Subject: Response to Remedial Action Design Report  
Spic and Span, Inc. (FMR)  
4301 N. Richards Street, Milwaukee, WI  
DNR BRRTS # 02-41-585636 / FID # 241040690

The Wisconsin Department of Natural Resources (DNR) reviewed the *Remedial Design Report* and the updated Hazardous Waste Determination, dated March 27, 2024 (Report) for the case identified above. The Report was prepared and submitted on your behalf by your consultant, Ramboll Group (Ramboll). The Report was submitted with the applicable technical assistance fee for providing review and response as required under ch. NR 749, Wis. Admin. Code.

**FIGURE 6-REVISED**

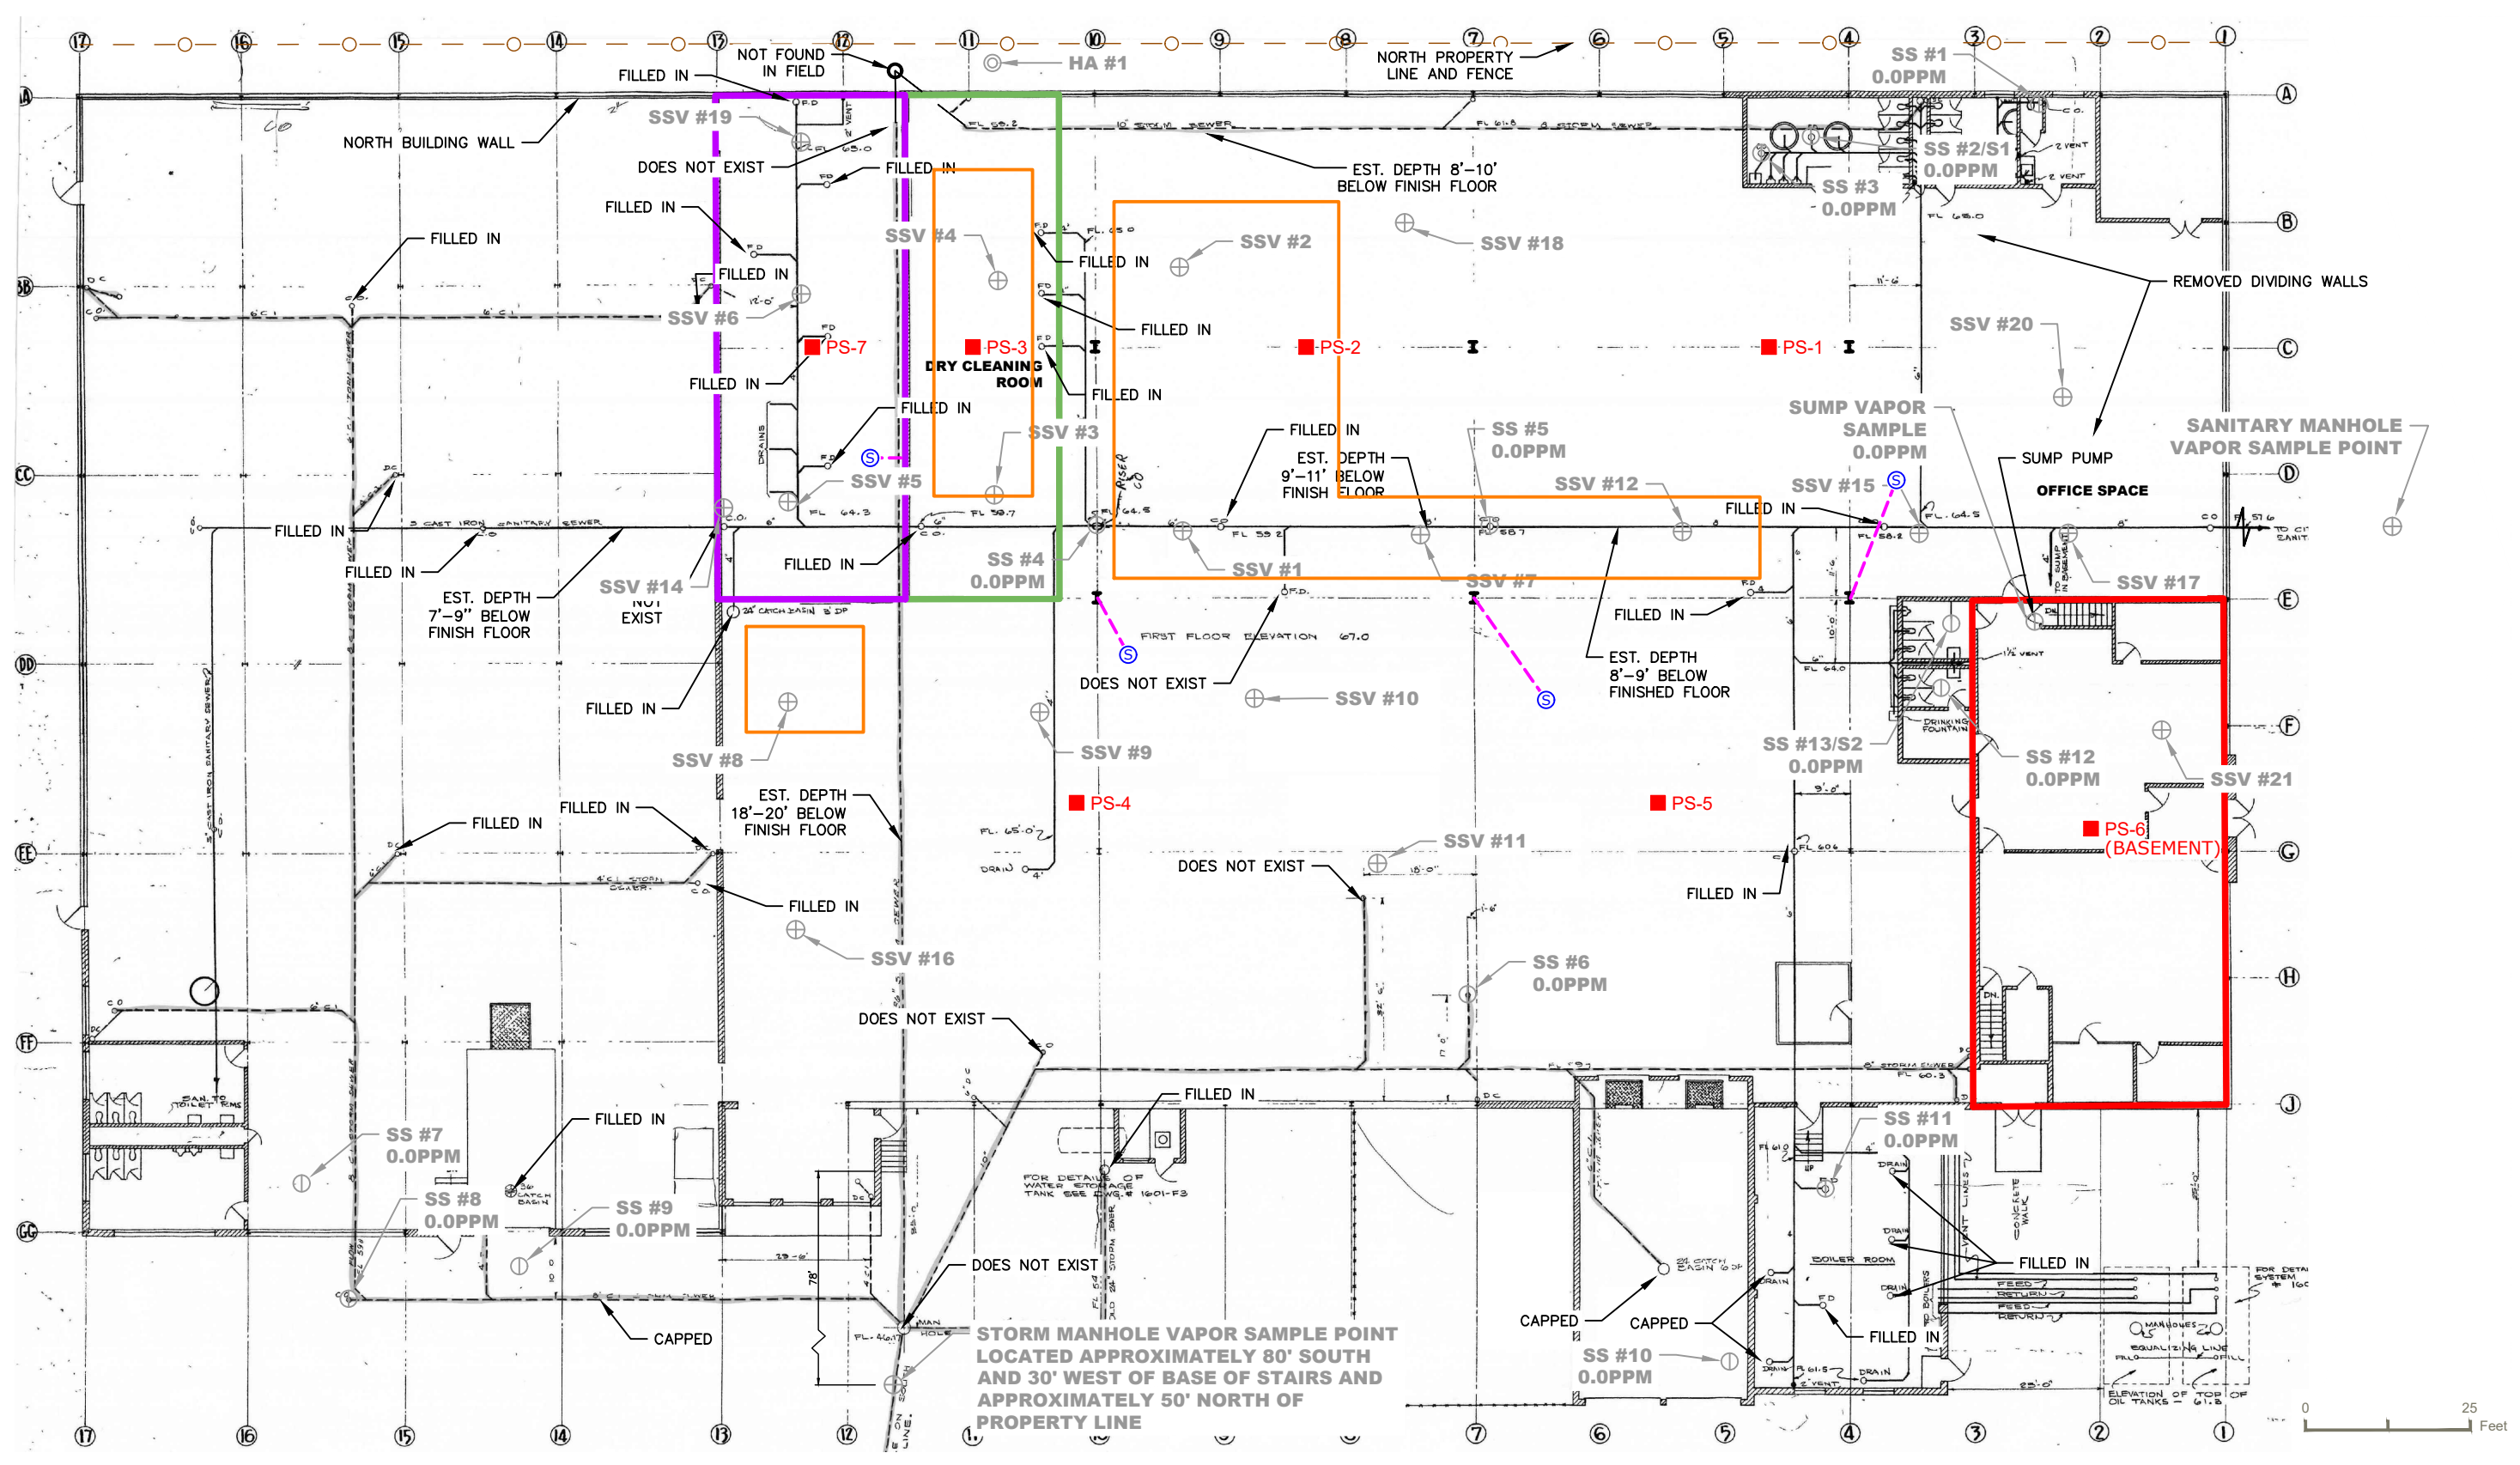
In addition to the proposed indoor air sample locations, indoor air samples should also be collected from the basement, An indoor air sample location was proposed in the basement (see attached Figure 6). office space, This is above the basement and is not needed. the solvent-based cleaning room, An indoor air sample location was proposed in the solvent based cleaning room (see attached Figure 6). and west of the solvent-based cleaning room. There is no indication that vapor impacts extend into this area and the seven indoor air samples proposed in conjunction with the pressure field extension testing are considered to be more than adequate for the area of concern.

**FIGURE 7-EXHIBIT  
 FOR DISCUSSION**

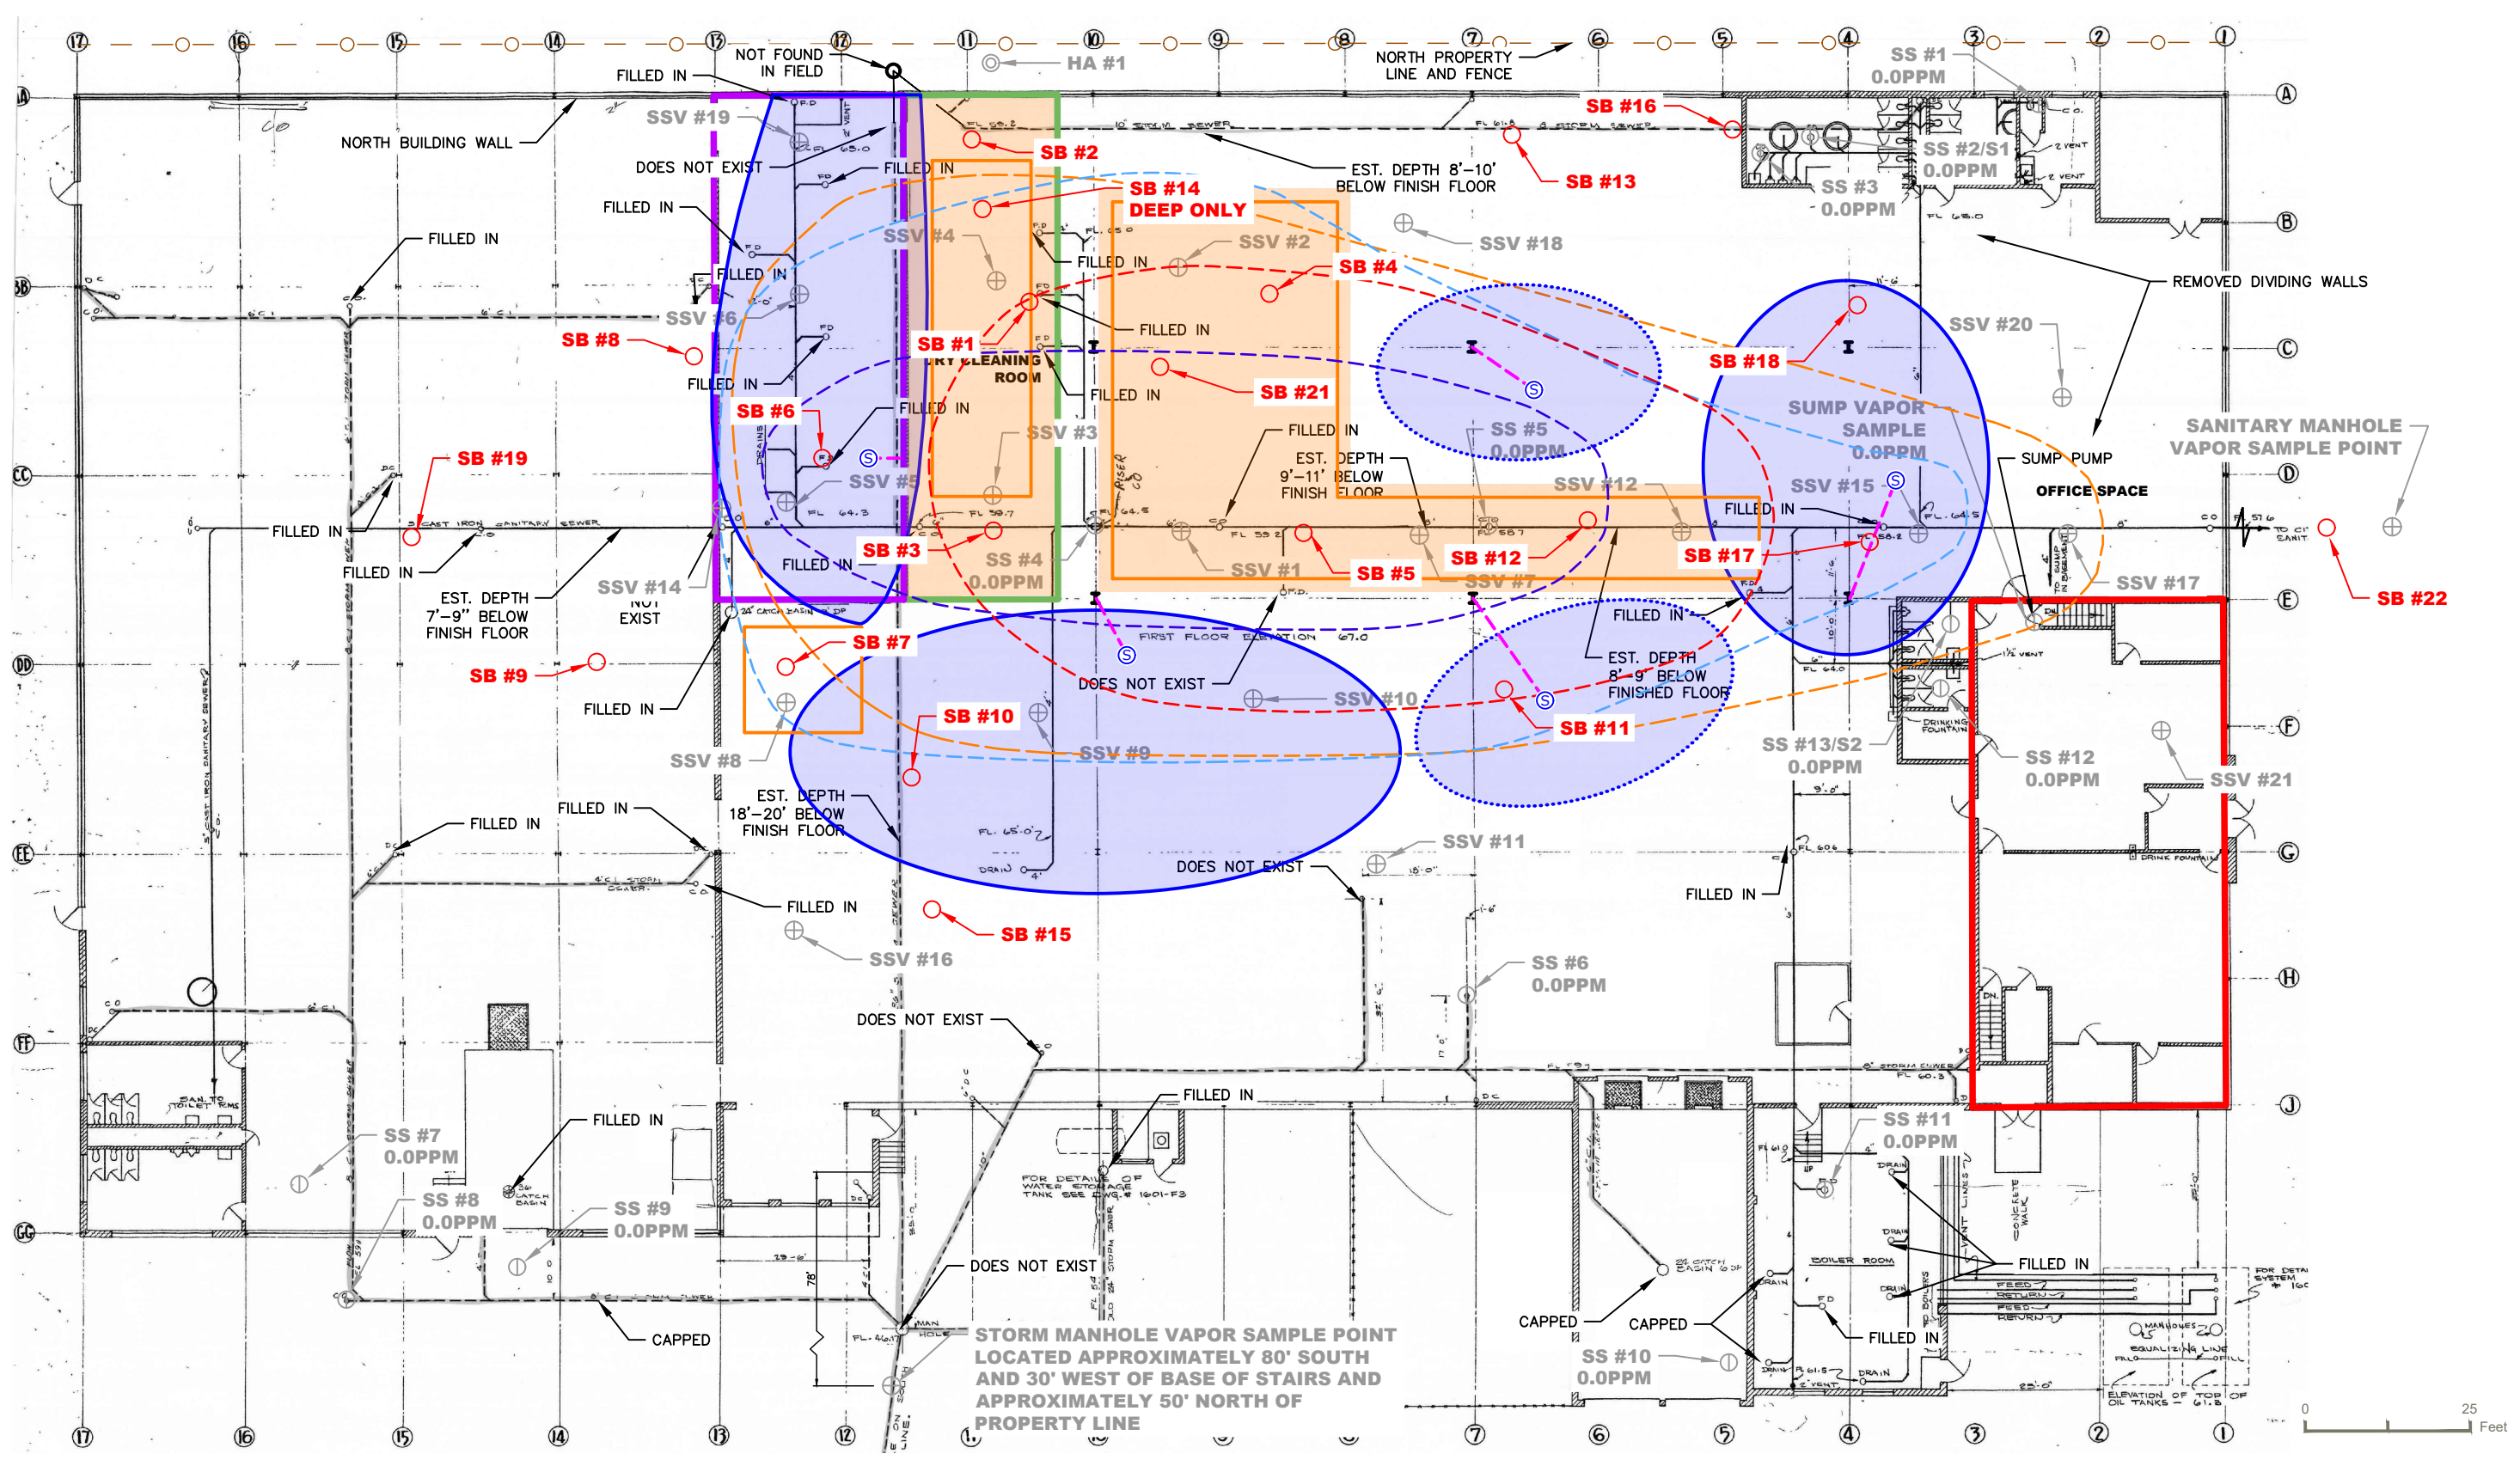
The anticipated SSDS radius of influence provided in the Report does not include all areas where sub-slab vapor

concentrations exceed the small commercial VRSL. **The SSDS should be designed to influence all areas identified with impacts greater than the small commercial VRSLs, including, but not limited to,** areas of excavation, in the vicinity of soil boring SB-11, SB-11 is within the area shown for Pressure Field Extension Testing, in the vicinity of sub-slab sample SSV#17, The area around SSV#17 is at the western edge of the contaminant plumes. It is cut off from sources to the west by the sub-slab depressurization sump, is close to the exterior wall, and is located in an open area. As such it is not likely to be a significant long-term source of interior PCE and TCE vapors. and west of sub-slab SSV#6 (west of the solvent-based cleaning room). The sub-slab vapor impacts did not extend into this area and there is no indication that a system should extend into this area; however, over time the field of influence for the proposed sub-slab depressurization system will likely begin to reduce sub-slab pressure in this area as well. A new figure, Figure 7, is attached for reference that includes the soil borings with the influence areas.
